TO: Town of Parker Recreation Dept.
FROM: Julia Duncan, Associate Planner
DATE: January 23, 2025
SUBJECT: SP24-124; Salisbury North MDP F1 AMD 2 L1 - Park Expansion Phase 1
Review Comments 01

SALISBURY PARK NORTH PHASE 1

TOWN OF PARKER SITE PLAN

Drawing
COMMUNITY HUB -
EXTERIOR
ELEVATIONS

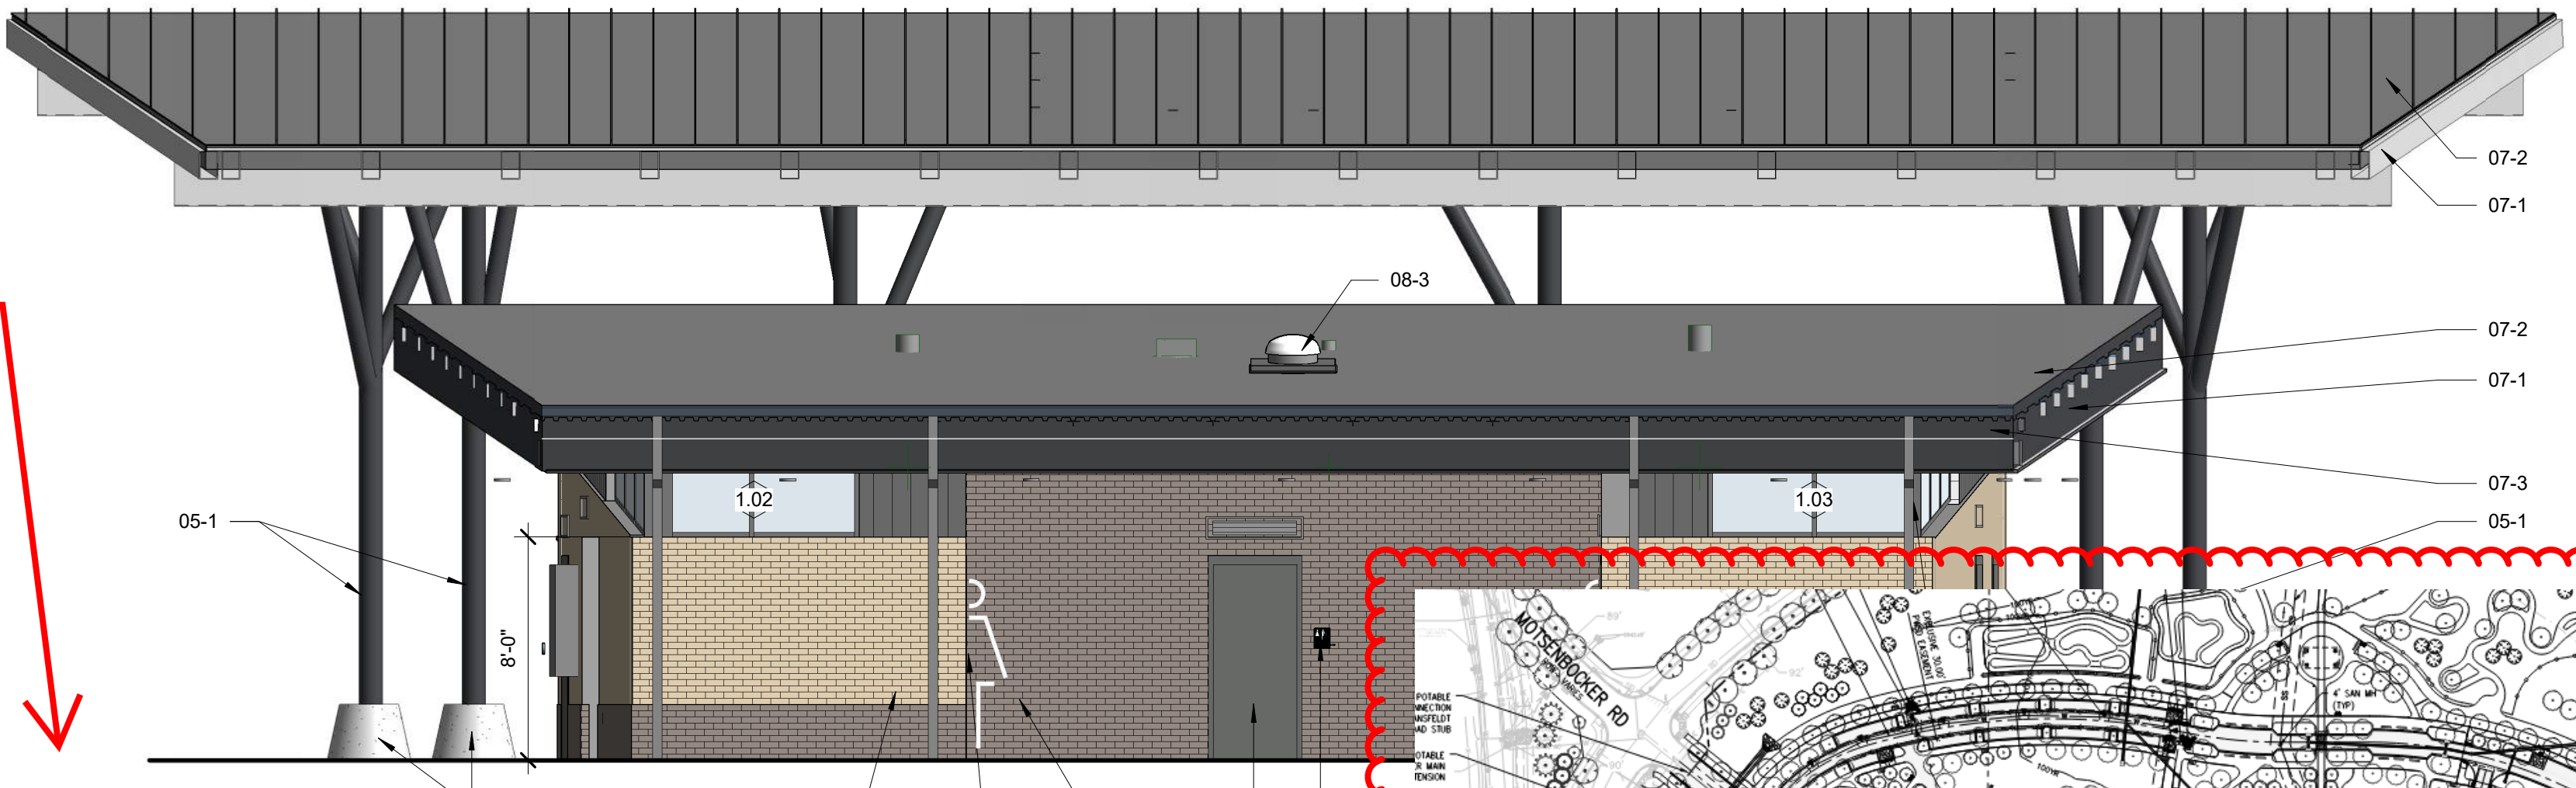
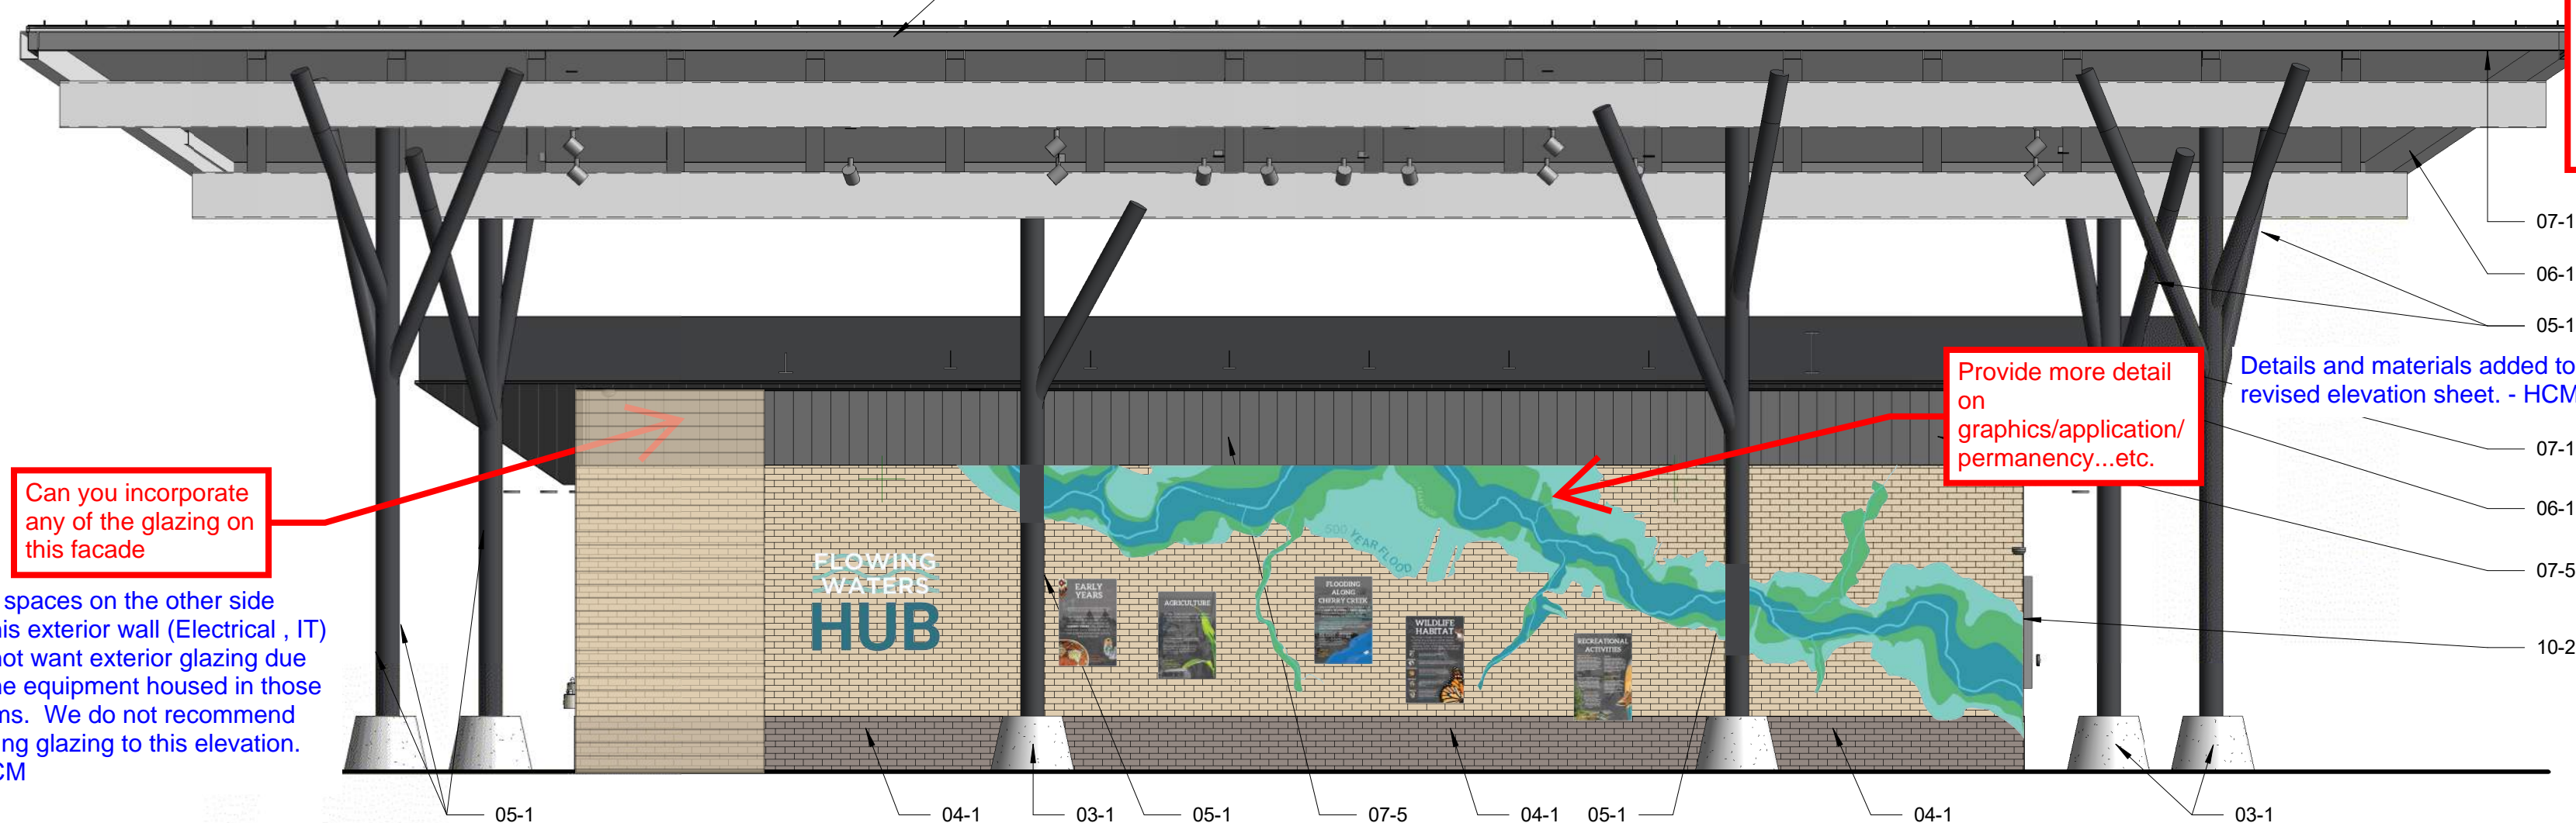
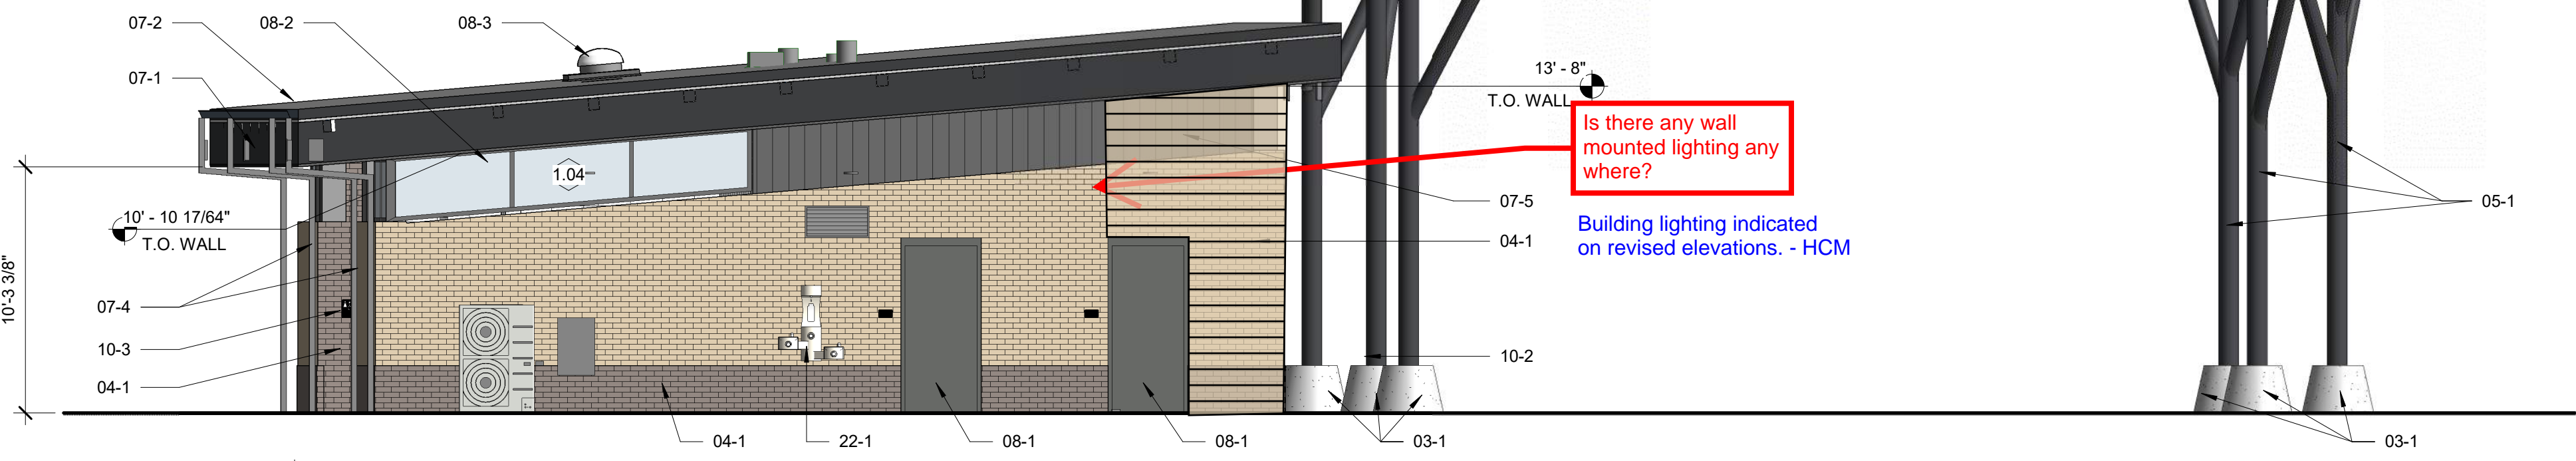
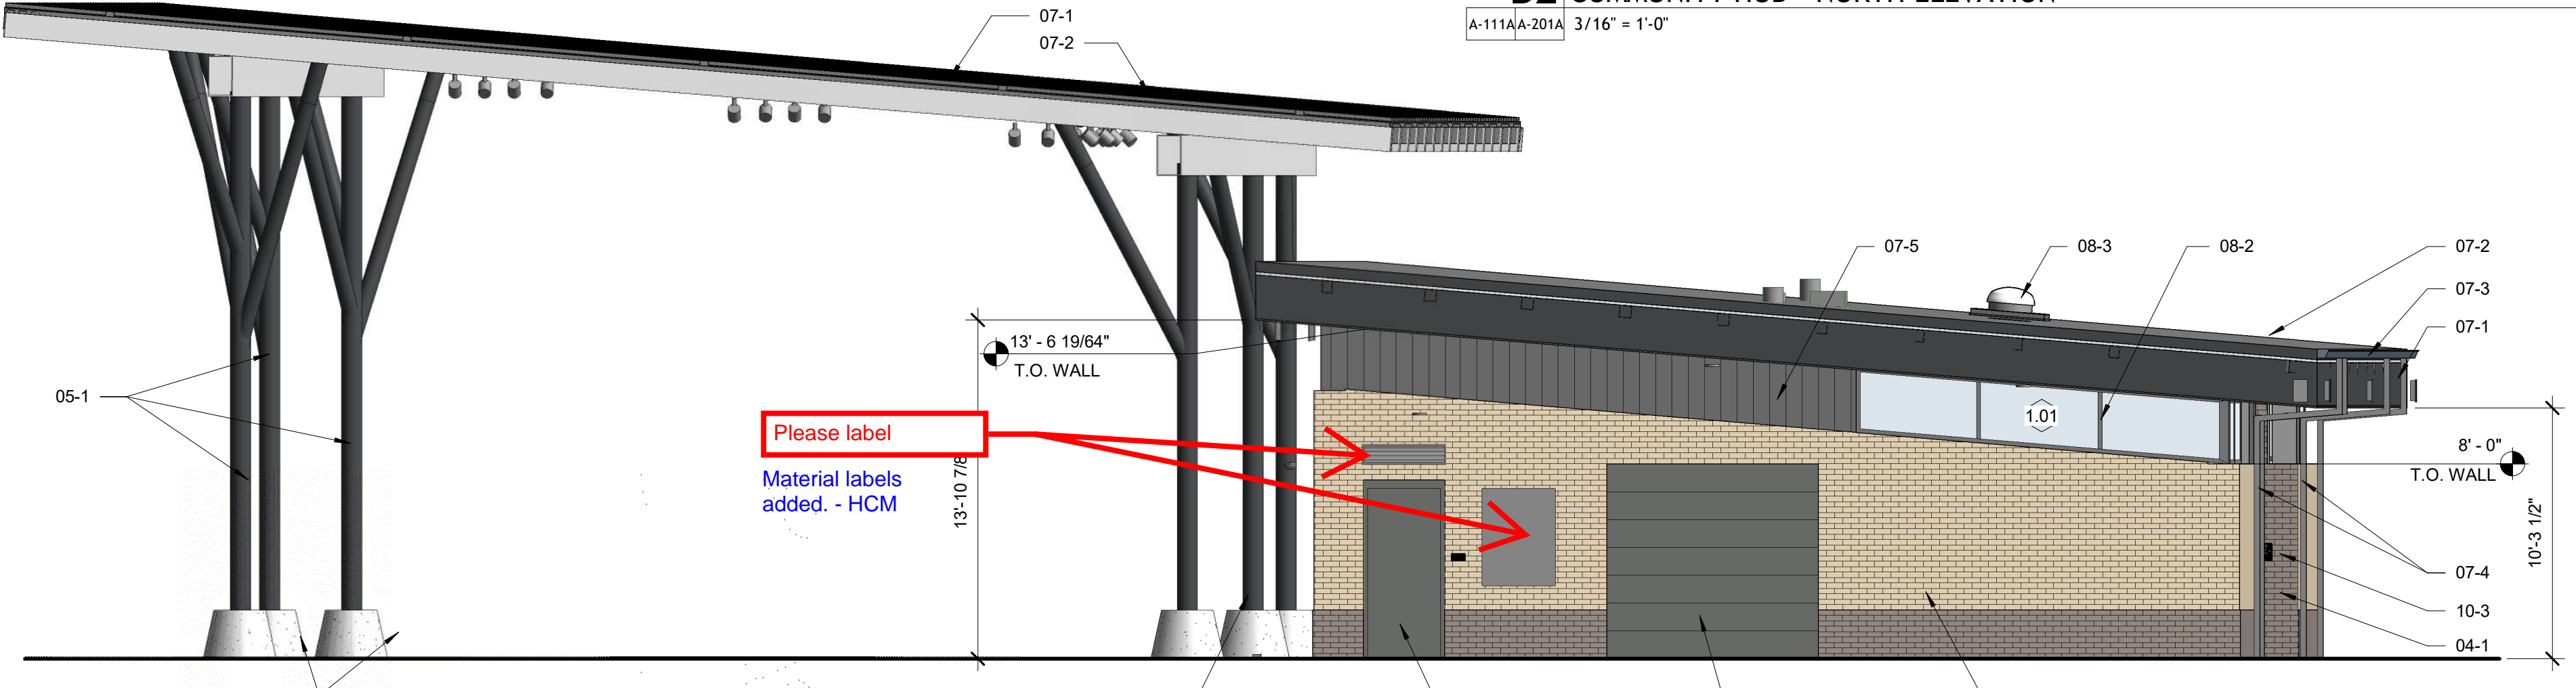
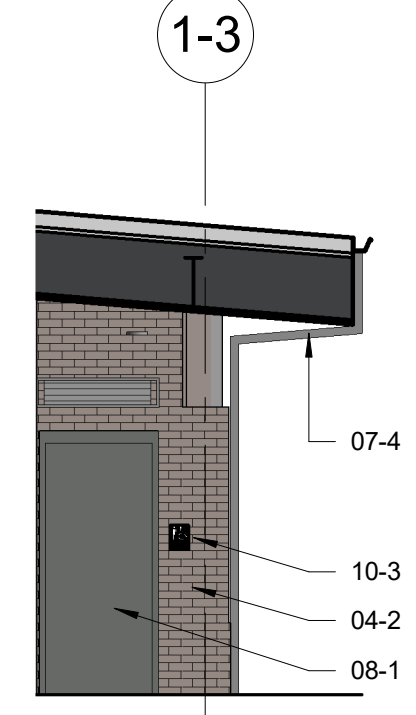
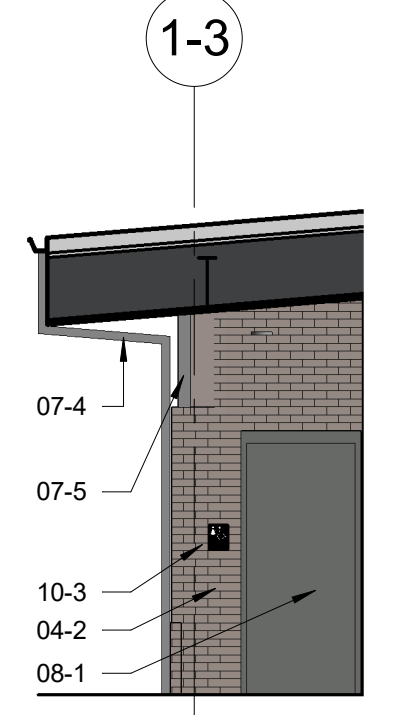
Break elevations into multiple sheets, max 2 on each sheet, dimensions all heights and widths on all elevations.

Show building footprints on same sheet of elevations, indicating plane breaks

Include a small site plan on all elevations building sheets showing where these buildings are

Provide more detail on graphics/application/permanency...etc.

Can you incorporate any of the glazing on this facade

Is there any wall mounted lighting anywhere?

Elevations broken out with building footprint and plane breaks indicated on revised elevation sheets. - Note that the Hub building has been removed from this phase so we have no longer included these sheets. HCM

Site key plan is added to all revised elevation sheets. - HCM

The spaces on the other side of this exterior wall (Electrical, IT) do not want exterior glazing due to the equipment housed in those rooms. We do not recommend adding glazing to this elevation. -HCM

Building lighting indicated on revised elevations. - HCM

Please label material labels added. - HCM
